SERVICE BULLETIN

Document No. 159-023-00, Rev. 2

Subject: R44 Cargo Hook Suspension

Figure 1 Suspension Removal

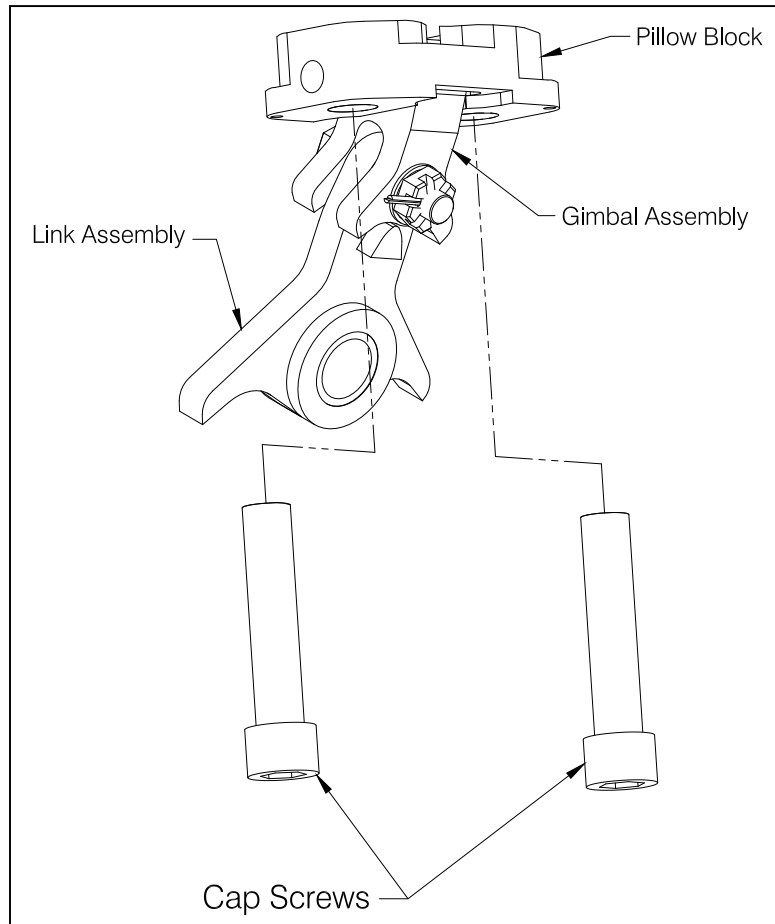
Description: The R44 cargo hook suspension system provides the means through which the cargo hook is attached to the aircraft. It includes a Pillow Block, Gimbal Assembly, and Link Assembly and associated hardware (refer to Figure 1 for visual identification of the configuration subject to this Service Bulletin). In April of 2007, an operator, during fertilizer bucket operations, experienced a failure of the Link Assembly (P/N 232-050-00). Time between overhaul restrictions were put in place for the suspension system when it is used for fertilizer bucket work or other operations where a torsional load is imparted into the suspension system. These restrictions were put in place until a re-designed suspension system was developed.

1. Remove the hardware attaching the Cargo Hook to the Link Assembly and remove the Cargo Hook. Retain the cargo hook attach hardware.
2. Remove the safety wire from the cap screws and remove the cap screws to remove the pillow block and suspension assembly components (see Figure 1). Retain the cap screws.

Figure 2 Suspension Installation

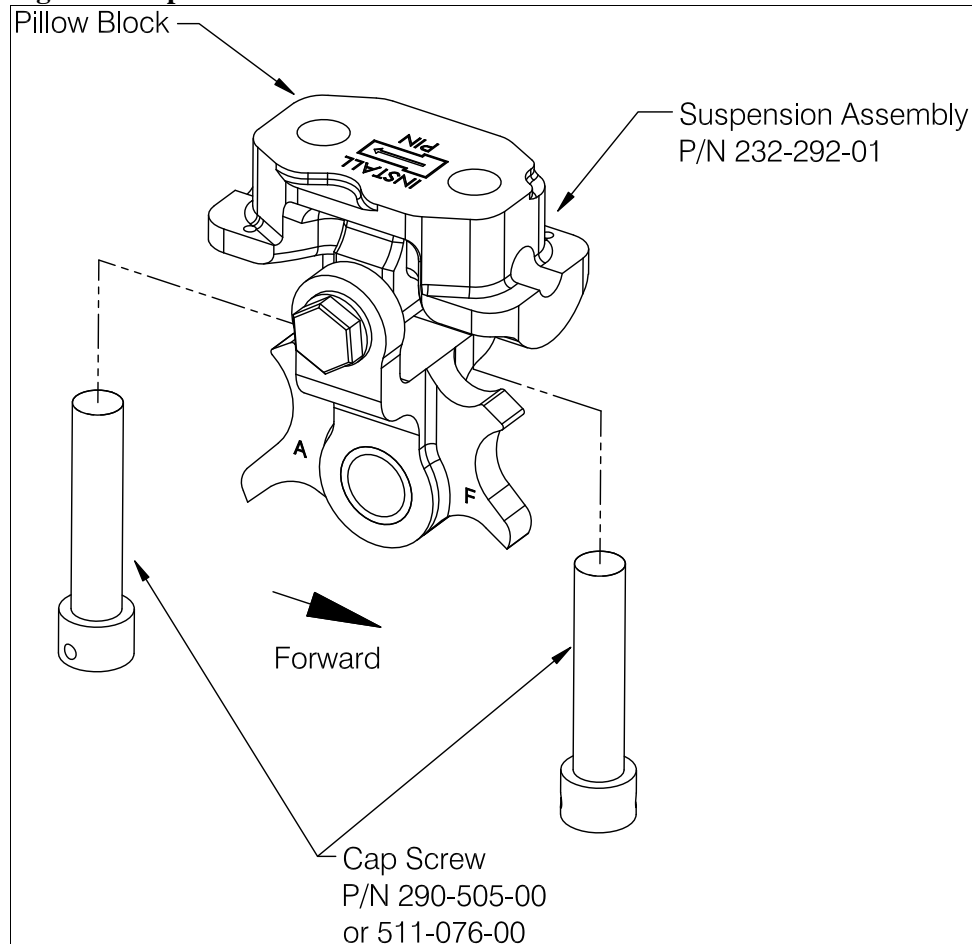
1. Apply sealant to the side of the Suspension Assembly (P/N 232-292-01) Pillow Block which is to be installed against the belly skin.
2. Orient the Suspension Assembly as shown in Figure 2.1.1 and secure it to the helicopter with the two P/N 290-505-00 or P/N 511-076-00 cap screws.

Install the Suspension Assembly so that the engraved "F" is forward and the engraved "A" is aft as shown in Figure 2.

3. Torque both cap screws to 26 ft-lbs.
4. Safety-wire the cap screws to the ears on the pillow block.
5. Re-install the cargo hook, re-using the hardware removed previously (see Figure 3).
